Steepbank Mine Project

Supplemental Information Response

**SUPPLEMENTAL INFORMATION RESPONSE
STEEPBANK MINE PROJECT
EUB APPLICATION NO. 960439
AEP APPLICATION NO. 020-95, AND FILE NO. 27551**

The following information is provided in response to the Energy and Utilities Board and Alberta Environmental Protection supplemental information request dated July 12, 1996. The following response follows the outline of your supplemental request letter.

Figure 5.8-7

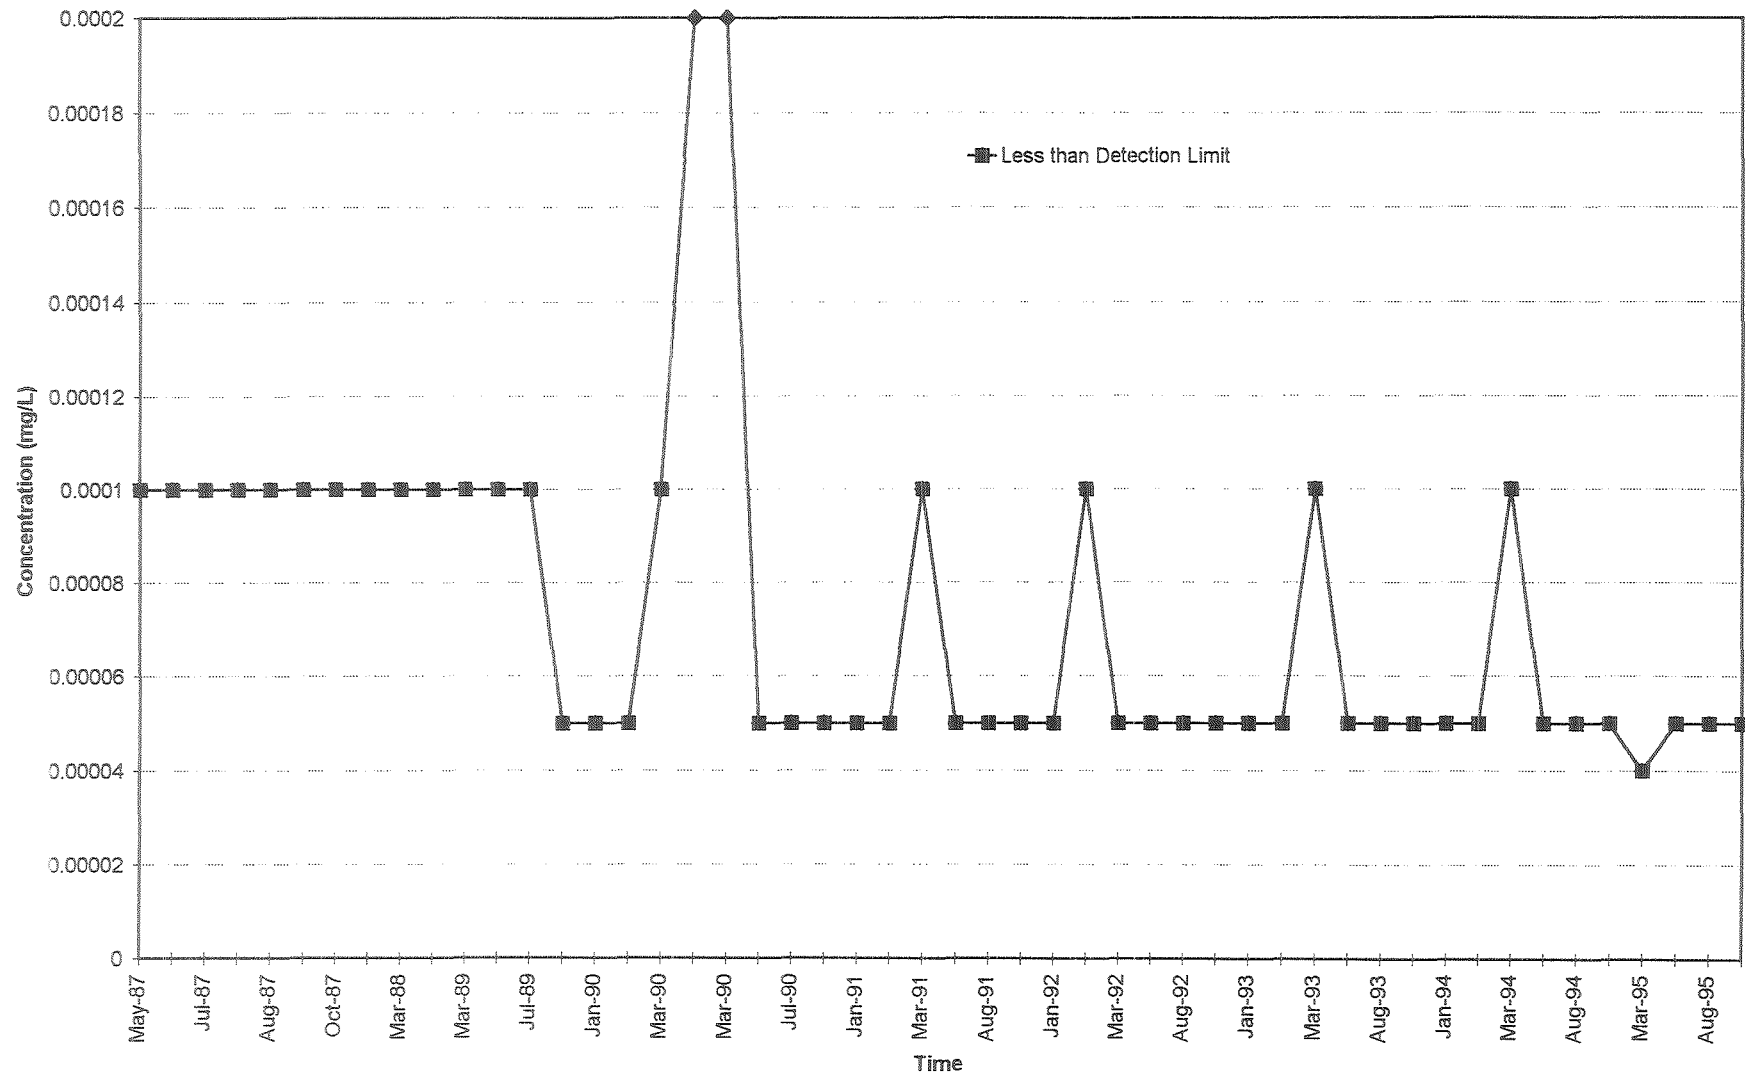
Q5.8 Provide time series graphs for each of the background river substances that indicated potential to exceed in-stream guidelines, either naturally, or as a result of Suncor's discharges (*Athabasca River Water Releases Impact Assessment, May 1996*).
